November 25, 2019

Re: Norfolk, MA – The Residences at Norfolk Station,
194 Main Street
Traffic Assessment Review

Source: Nearmap (April 2019)

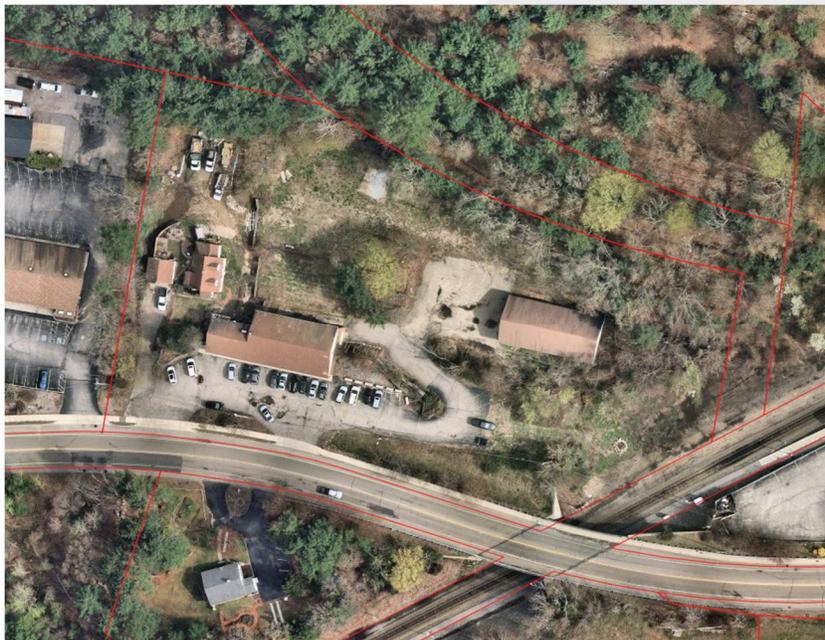
1. The existing site, as shown below, provides a commercial building, a single-family home, and a garage. The site is located approximately 625 feet east of Boardman Street and 650 feet west of Independence Drive. Access is provided by two driveways to a parking lot with approximately 25 parking spaces. The residence and garage are accessed by additional internal driveways connected to the main parking facility.
